Amendments to the Drawings:

REMARKS/ARGUMENTS

FIG. 2

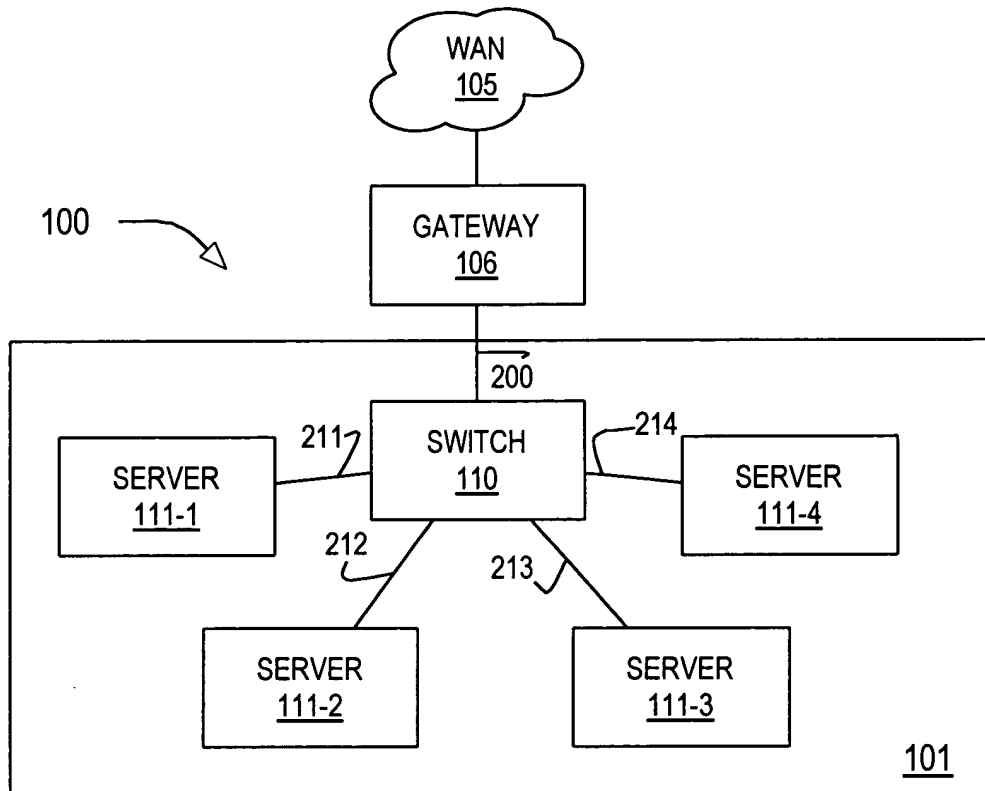
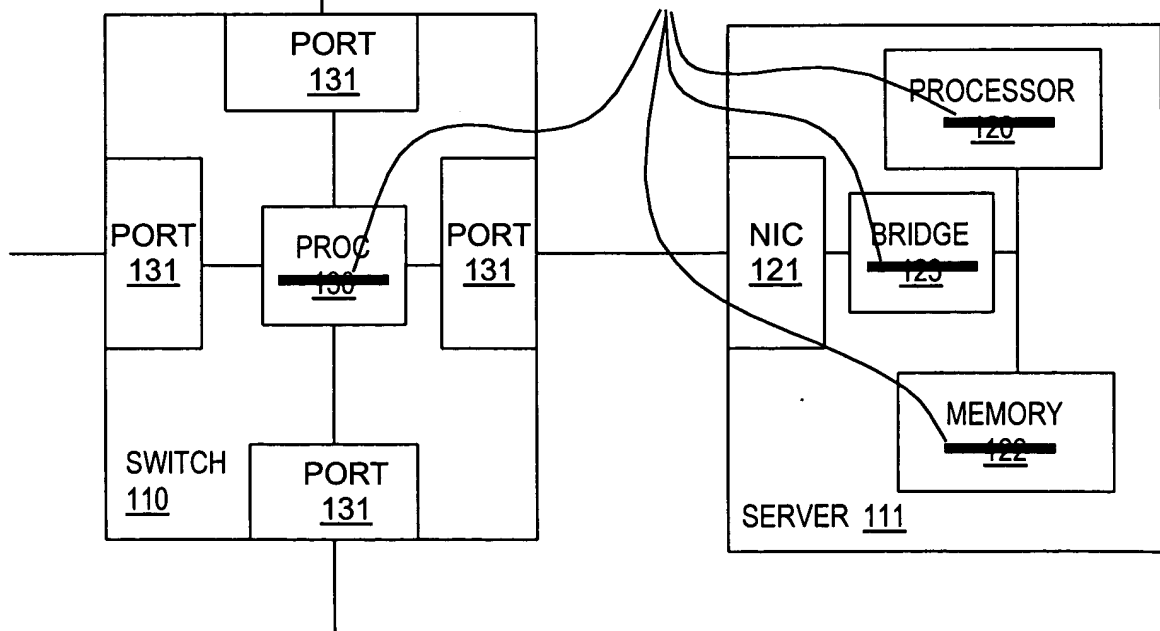
The Examiner objected to originally submitted FIG. 2 because it included reference characters not mentioned in the description. In response, Applicant has submitted a proposed replacement drawing page for sheet 1 of 3 of the originally submitted drawings. The offending reference numerals have been removed from the proposed replacement sheet. No other changes have been made. Applicant respectfully requests the Examiner to accept the proposed drawing sheet and withdraw the objection.

DELETE INDICATED FIG. 1
REFERENCE NUMERALS

Applicant has submitted with this response a proposed replacement drawing sheet for Sheet 1 of 3 of the originally submitted drawings. Four reference numerals found in the originally submitted drawing sheet have been deleted in the proposed drawing sheet consistent with the Examiner's appropriate determination that the drawings contained reference numerals not found in the specification. No other changes have been made to the drawings.
